工程指示 / 要求簡箋(E.I.)

工程指示編號：EI / 3706 / 21 修改版次：
 工程編號：J - 852 工程名稱：亞皆老街中電
 工程項目：平台 G/F 趟摺門 90 碰 資料查詢
 收件人：生統 / 平少 發件人：Ant Yeung 日期：05/08/2021

Re : Design, Supply & Installation of Aluminium Window & Cladding, Curtain Wall, Glass Wall, Louvers and Glass Balustrade Nominated Sub-Contract at K.I.L. 6038RP, K.I.L.6037RP, K.I.L. 6036RP, K.I.L. 6035RP & K.I.L. 6005, Nos. 139-147 Argyle Street, Kowloon.
Query on Glass Door at G/F Multi-Functional Room 3 (RF1070)

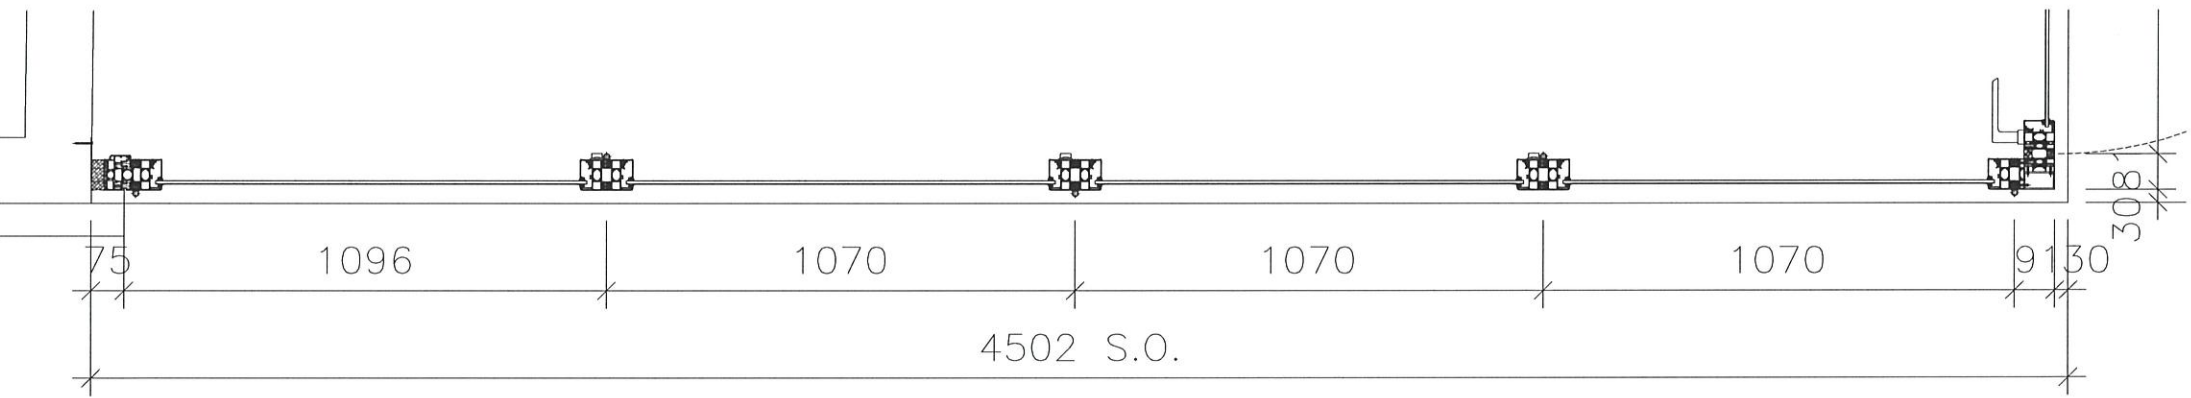
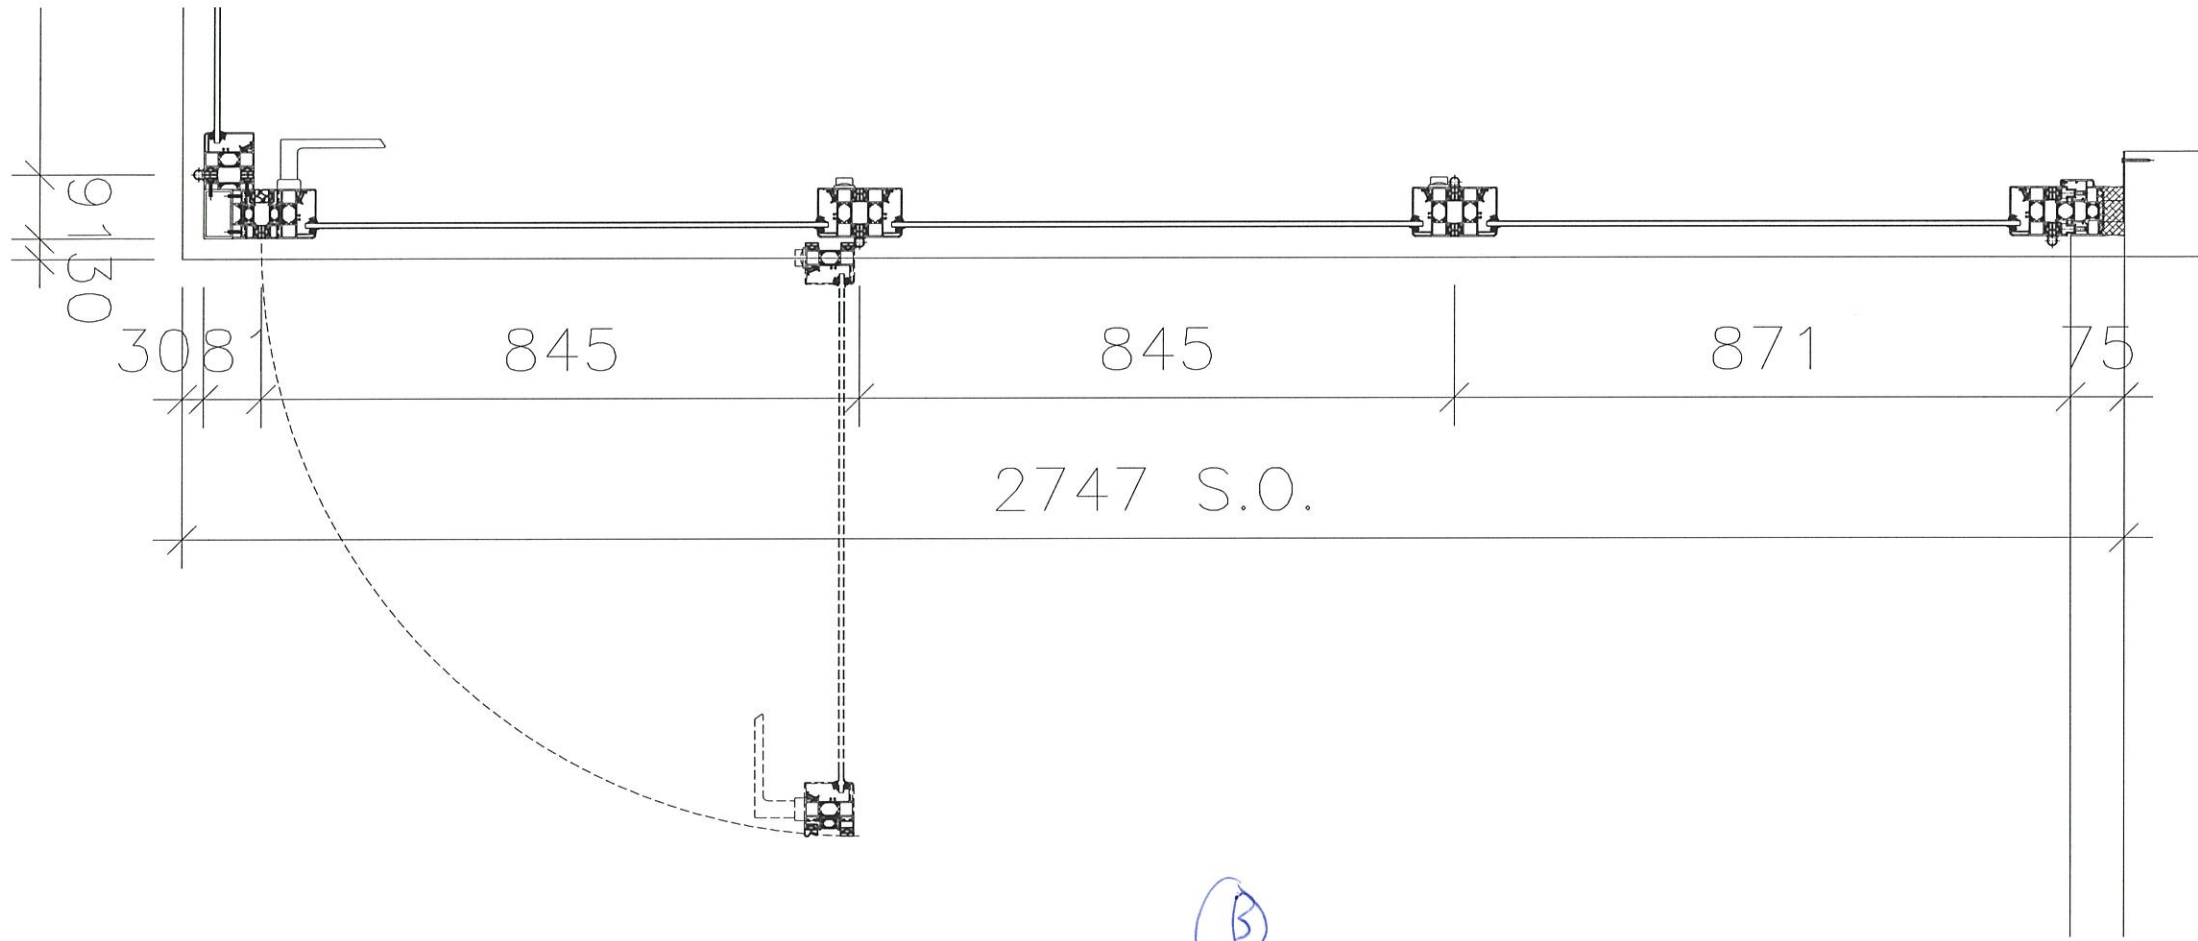
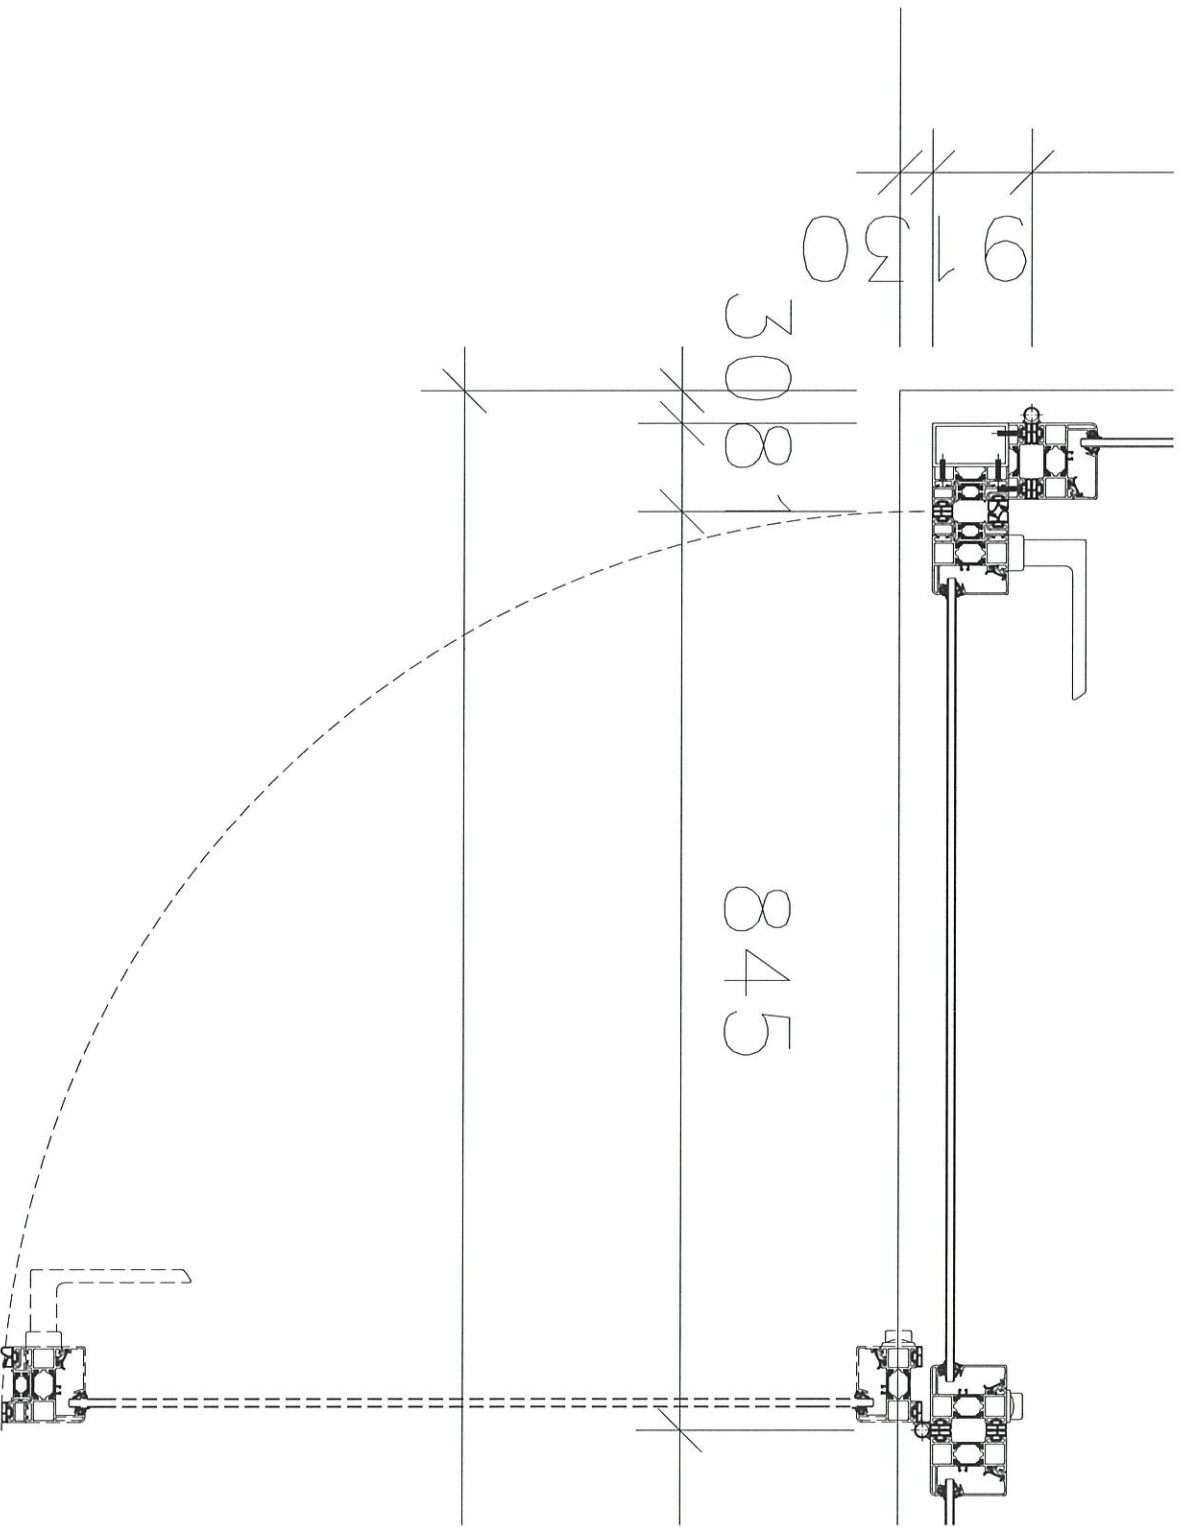
此位置有 2 幅趟摺門，請提供

1. 此 90 碰是否可行

2. 貨期時間

GROUND FLOOR PLAN
 (G/F)

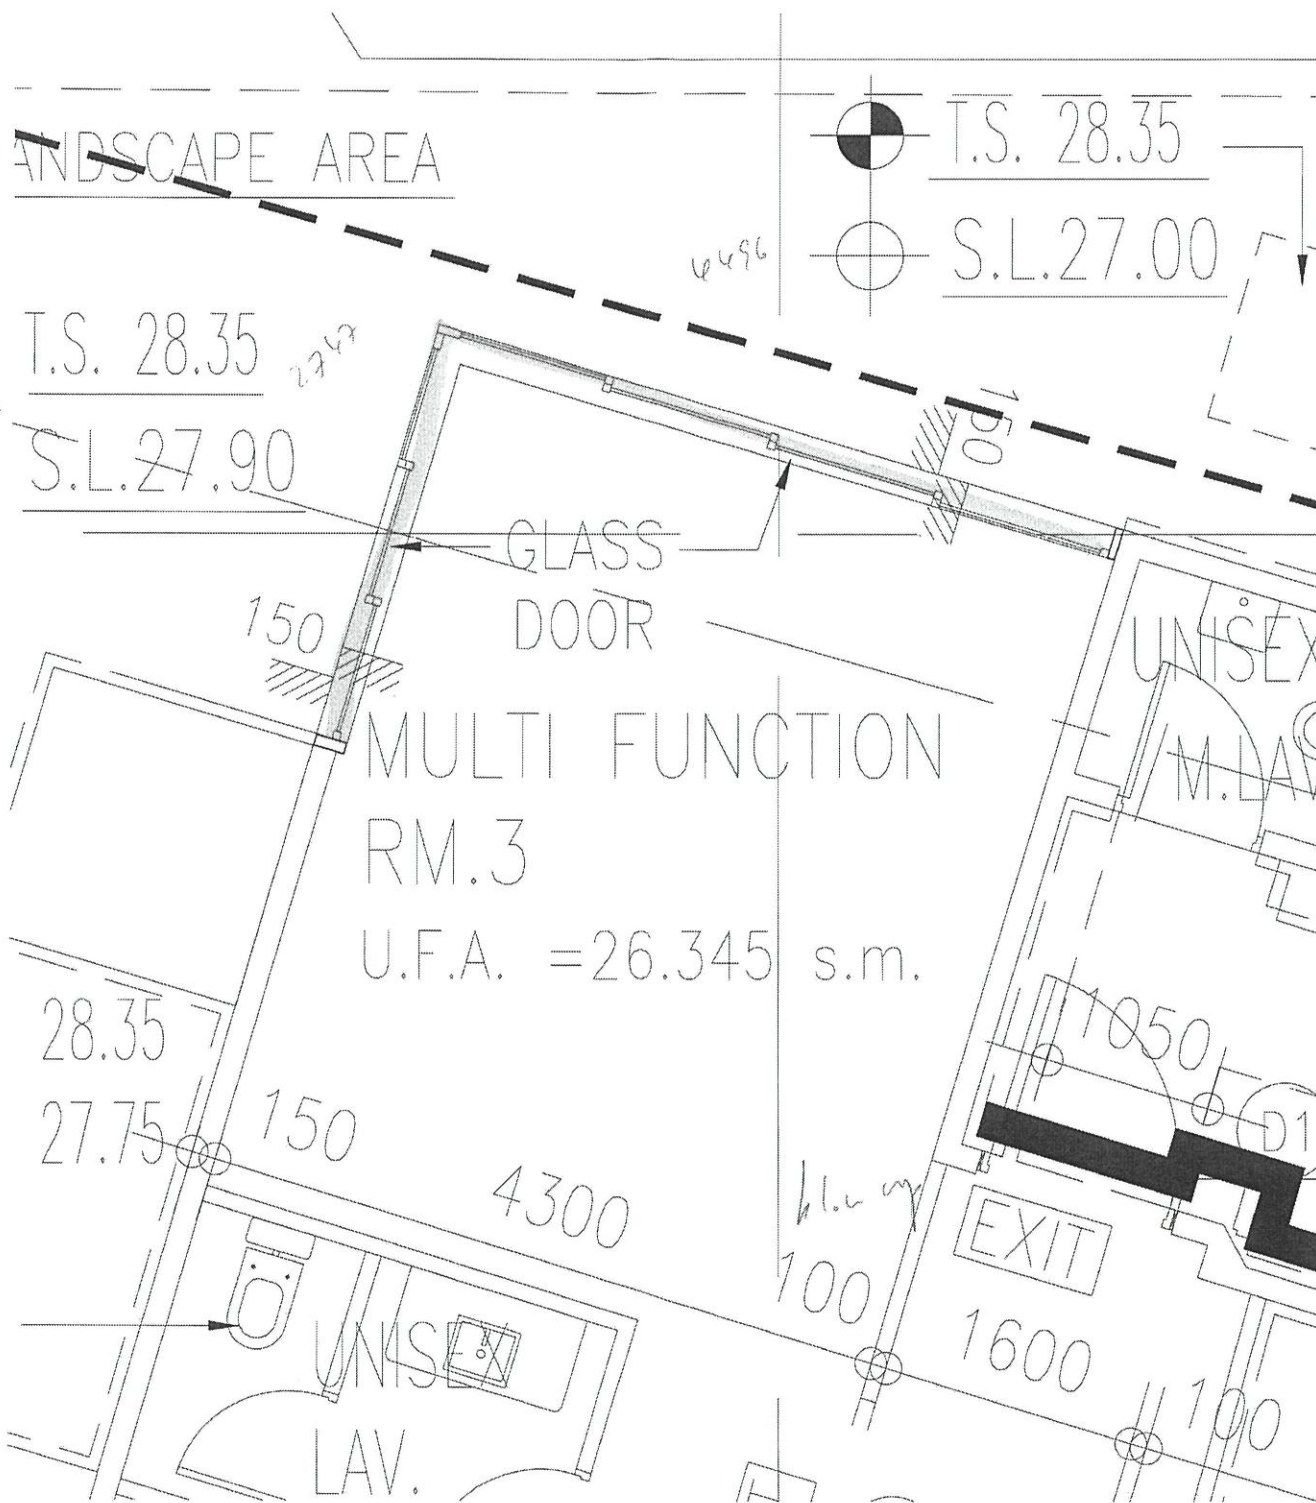
Regarding the captioned project, we would like to request the information about the Glass door at G/F Multi-Functional Room 3.

According to our tender drawing, it should be the Double Swing French Door at this location. And, referring to the latest GBP, it shows the Glass Door/ Sliding Door. Please Clarify which was kept under the midi scope. Please Issue A.I to cover the design change.

If proceed with new design, please provide the followings,

- 1) the design intent for the glass door :
- 2) The S.O. for Glass Door (Height x Width)
- 3) Setting out for Glass Door
